6C Containment Debris Protection for ECCS Strainers

The information in this appendix of the reference ABWR DCD is subject to several changes due to the adoption of a complex ECCS strainer design (e.g. Cassette Type Strainer). Consequently, for clarity it is presented in its entirety with the following departures incorporated. This strainer design has been used at numerous BWRs in Japan and numerous PWRs in the United States. The strainer is described in this appendix. Departure STD DEP Vendor changes General Electric (GE) to Toshiba in Section 6C.1.

STD DEP 6C-1 (Figure 6C-1)

Figure 6C-1 Cassette Strainer Cutaway

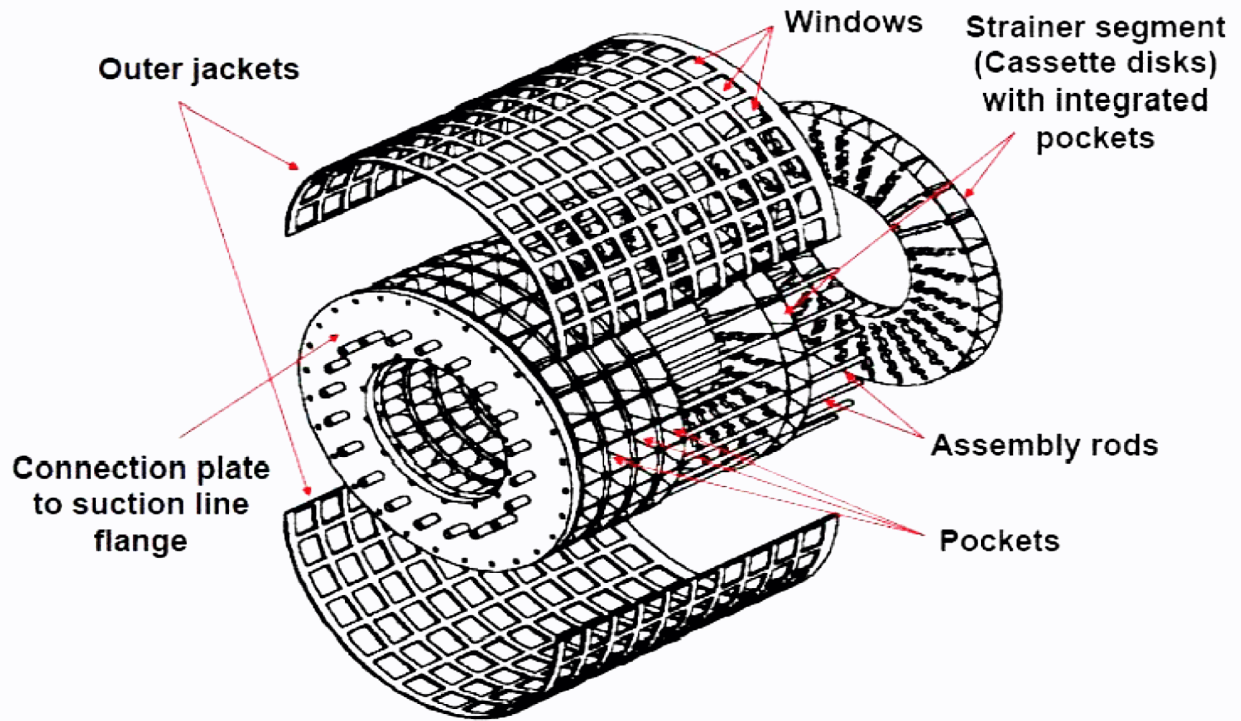
The suction strainers design at Perry preceded and did not meet the current regulatory requirements. The ABWR ECCS suction strainers will utilize a "T" arrangement with conical strainers on the 2 free legs of the "T" a cassette type strainer design. This design separates the strainers so that it minimizes the potential for a contiguous mass to block the flow to an ECCS pump. The design of the strainers will be based on Regulatory Guide 1.82, NUREG/CR-6224 (Reference 6C-4), NUREG/CR-6808 (Reference 6C-5) and the Utility Resolution Guidance, NEDO-32686-A. The cassette type strainer design is based on a set of cassette modules with U-shaped filter pockets attached to the cylindrical outer jacket. Each strainer consists of filter modules, the outer jacket and flange plates on each end of the cylindrical assembly. The filter module is constructed with cassettes which are arranged axially along the strainer axis. One cassette consists of pocket shaped filters which are arranged radially. A cut-away drawing of the strainer is shown in Figure 6C-1. The material used in the cassette type strainer is stainless steel. The cylindrical strainer assemblies are mounted in pairs on piping tees at each ECCS pump suction line. When the ECCS pump operates, the suction flow in the suppression pool runs into all pockets through the outer jacket windows. Each pocket has five flow paths from the inlet through the five perforated walls to the outlet of the pocket towards the cassette strainer. By using the cassettes with the pocket shaped filters, the strainer has an available filter area which is larger per volume than cylindrical and other shaped strainers. The number of cassettes and pockets is adjusted to produce a specific head loss performance for the strainer. To avoid debris clogging the flow restrictions downstream of the strainers, the size of the holes in the perforated sheets is chosen by considering specific flow paths of ECCS equipment and piping (for example, the containment spray nozzle and the ECCS pump seal cooling flow orifices). The strainers will have holes no larger than 2.1 mm.
